In the Drawings

REMARKS***Present Status of Application***

FIG. 1 (RELATED ART)
(PRIOR ART)

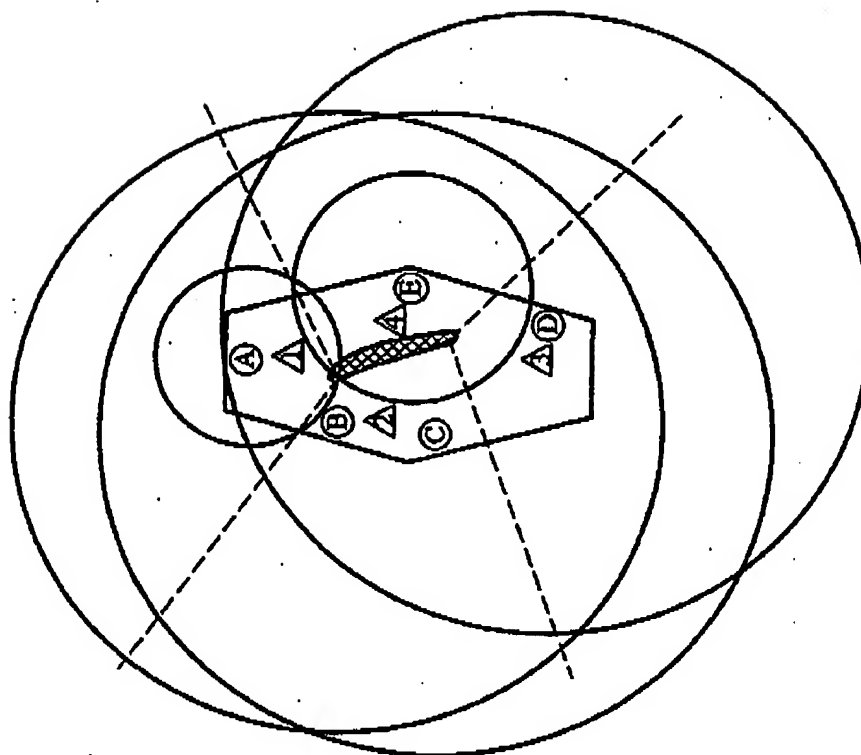
Please replace FIGs. 1-3 with the attached replacement sheets (wherein "Related Art" is replace by "Prior Art").

Also, Applicant has amended FIGs 1-3 to replace the designation of "Related Art" with "Prior Art," as requested by the Office Action.
